Access Compliance Report Public Rights-of-Way (Curb Ramps)

Main Street: AGAPANTHUS_ST		Cross Street: TUBEROSE_ST		Location:	NW
ADA ID: RPRK211111123519	Ramp Type: Type 4 - Parallel	Initial Pass/Fail: Fail	Overall Compliance: No	Severity Score:	16
Codes/Mitigation Info/Possible Solution			Field Measurements/Component Compliance

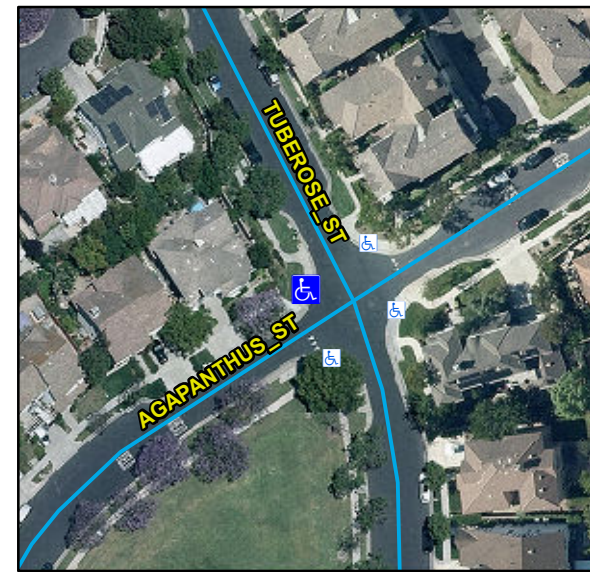
R204.3, R304.3.2, R304.5.3, STD 1115

Compliance	Description	Data	Compliance	Description	Data
N/A	Ramp Length LT (in)	134	N/A	Ramp Length RT (in)	130
Yes	Ramp Width LT (in)	58	Yes	Ramp Width RT (in)	58
No	Ramp Run Slope LT (%)	8.5	Yes	Ramp Run Slope RT (%)	3
Yes	Ramp Cross Slope LT (%)	0.7	No	Ramp Cross Slope RT (%)	2.4
N/A	Landing Present	N/A	N/A	DWS Provided	N/A
N/A	Landing Length (in)	N/A	N/A	DWS Contrast	N/A
N/A	Landing Width (in)	N/A	N/A	DWS Length (in)	N/A
N/A	Landing Run Slope (%)	N/A	N/A	DWS Full Width	N/A
N/A	Landing Cross Slope (%)	N/A		DWS Offset Type	N/A
N/A	Landing Movement Obstructed?	N/A	N/A	DWS Offset Left (in)	N/A
	Landing Movement Type	N/A	N/A	DWS Offset Right (in)	N/A
N/A	Landing Shared	N/A			
N/A	Clear Space	Yes			
N/A	Clear Space To Crosswalk (in)	N/A			
N/A	Marked Crosswalk 1	No	N/A	Marked Crosswalk 2	No
	Crossing 1 Direction	S		Crossing 2 Direction	E
	Marked Crosswalk 1 Width (in)	N/A		Marked Crosswalk 2 Width (in)	N/A
N/A	Ramp Inside Crosswalk 1	N/A	N/A	Ramp Inside Crosswalk 2	N/A

Remove & Replace Curb Ramp With Two New Directional Ramps or Equivalent.
